Addendum No. 3
March 17, 2025

Project: Brandon Valley Middle School Addition
Brandon, South Dakota
Project #3090

Architect: Architecture Incorporated

6.10D

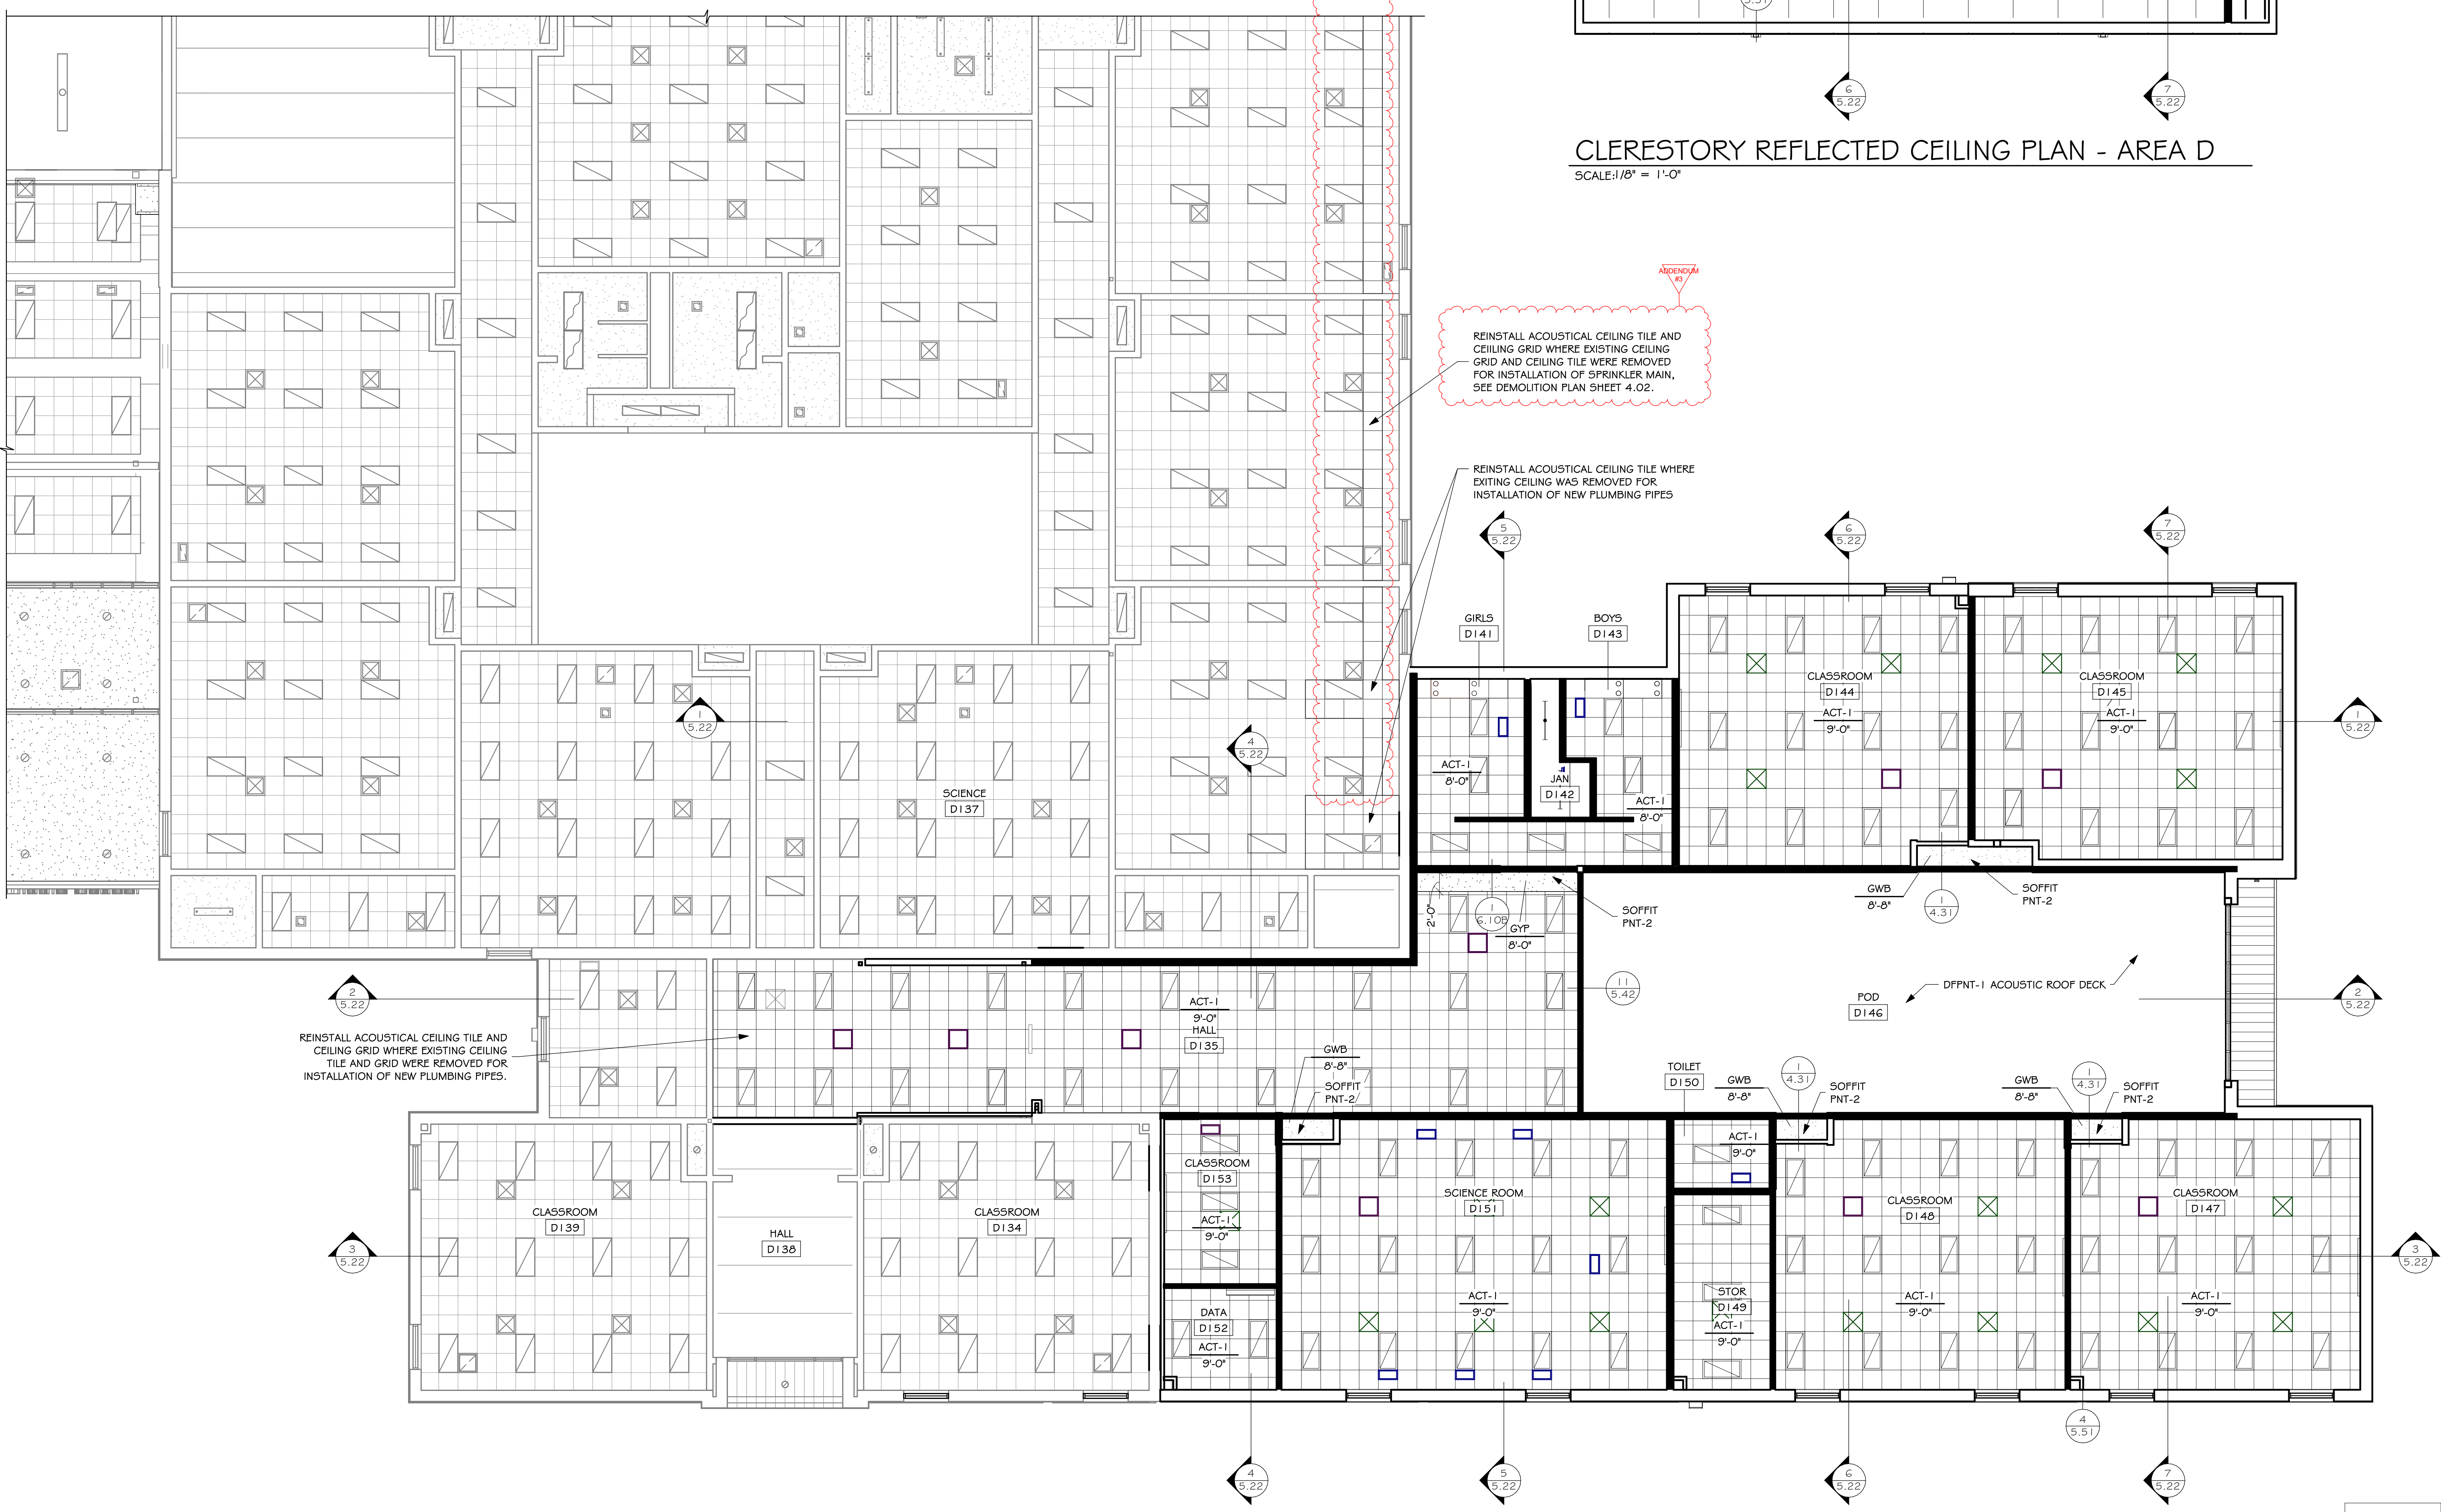
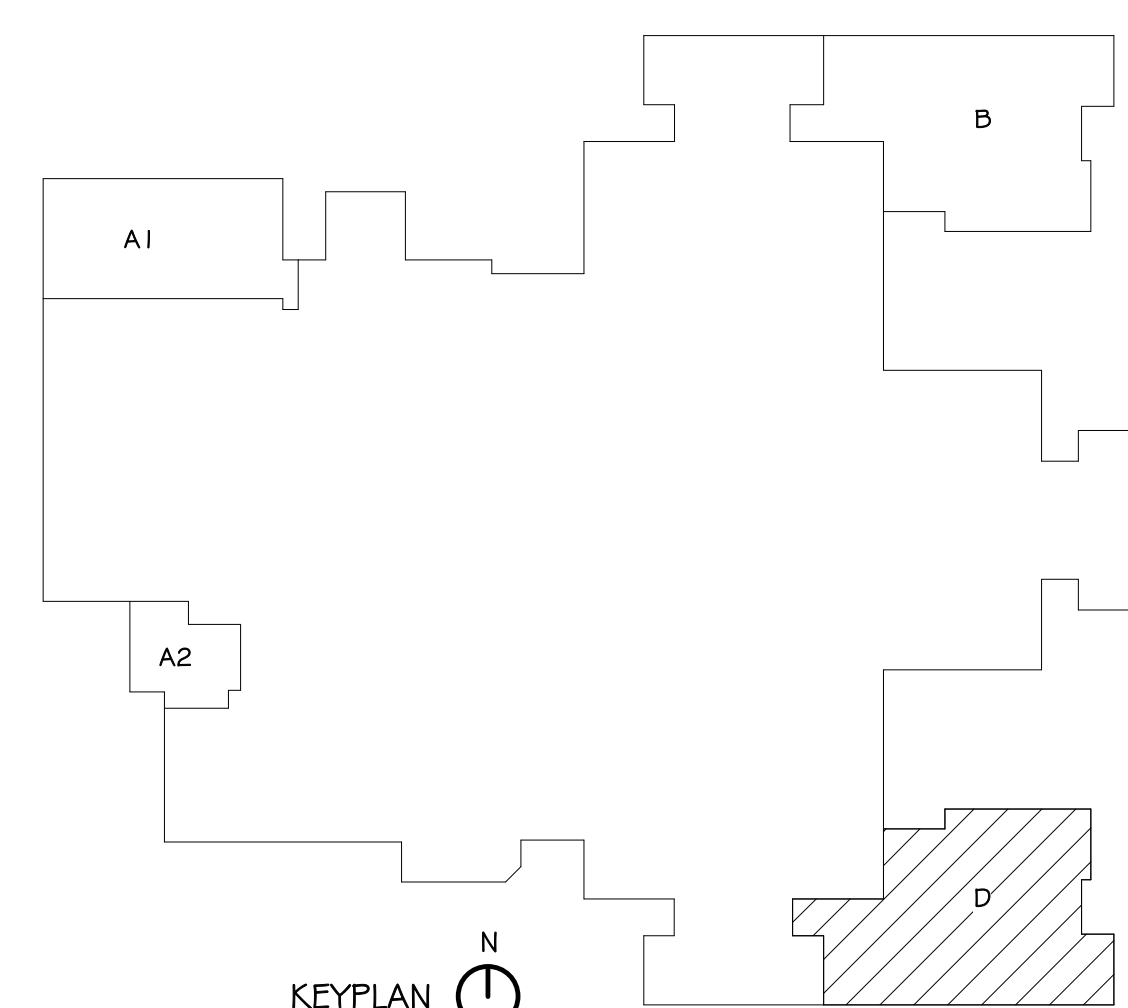
- b) Sheet 6.10B & 6.10D: Contractor shall remove and reinstall existing ceiling tile and grid to install new plumbing heating lines and fire sprinkler lines as shown on mechanical drawings.

REINSTALL ACOUSTICAL CEILING TILE AND CEILING GRID WHERE EXISTING CEILING GRID AND CEILING TILE WERE REMOVED FOR INSTALLATION OF SPRINKLER MAIN. SEE DEMOLITION PLAN SHEET 4.02.

REINSTALL ACOUSTICAL CEILING TILE WHERE EXISTING CEILING WAS REMOVED FOR INSTALLATION OF NEW PLUMBING PIPES

REINSTALL ACOUSTICAL CEILING TILE AND CEILING GRID WHERE EXISTING CEILING TILE AND GRID WERE REMOVED FOR INSTALLATION OF NEW PLUMBING PIPES.
